FOUNDATION INVESTIGATION REPORT
For
Proposed Overpass Structure Extension
At the Crossing of
Park Rd. and Hwy. 401
Township of E. Whitby, County of Ontario
Site No. 22-173
W.O. 72-11149 -- W.P. 44-71-06

Contract 77-133
Park Road Pedestrian Tunnel
Site #22-173
Deformation of Steel Tunnel Liner

Contract 77-133
Park Road Overpass Widening
Culvert Relocation at abutment footing

EXISTING CONDITION

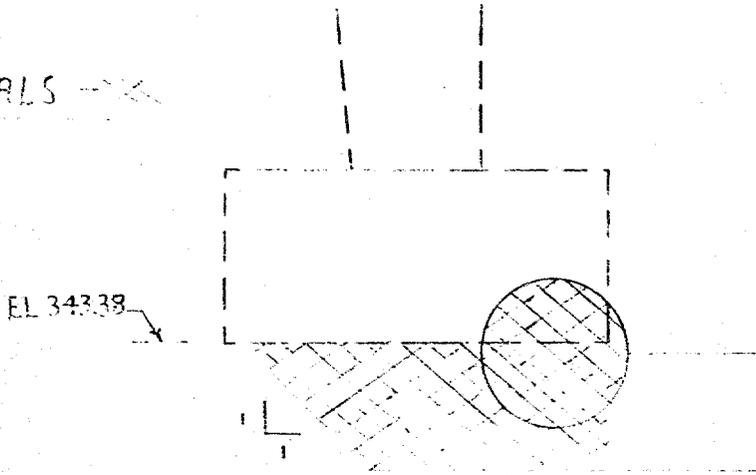
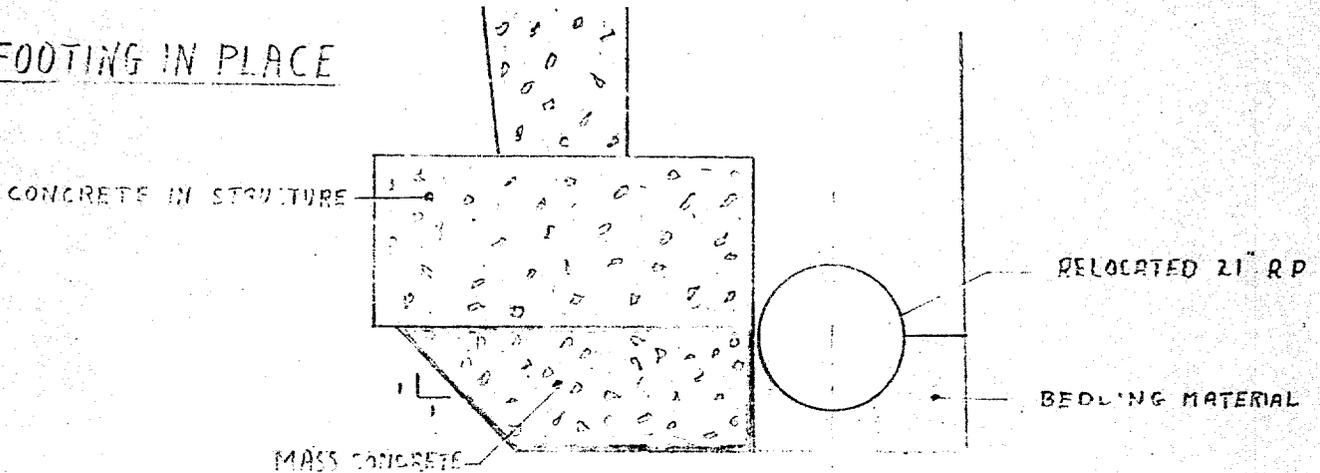
A 21" concrete storm sewer, previously placed under this contract passes under the N.E. abutment of the above structure widening. The invert of the pipe is approximately 1' below the base elevation of the footing. The bedding material extends 6" below this level.

It is necessary to realign the storm sewer outside the limits of the footing.

The pipe and bedding should be completely removed and backfilled with mass concrete through the length of the N.E. widening. The back of the excavation should be sloped at 1 to 1. The mass concrete should be placed within 12 hours after excavating to prevent softening of ~~the softening~~ of the foundation material.

At the time of the excavation it should be determined if the existing foundation has been undermined or disturbed and if so, repaired with mass concrete. The pipe may be relocated immediately beyond the footing limits.
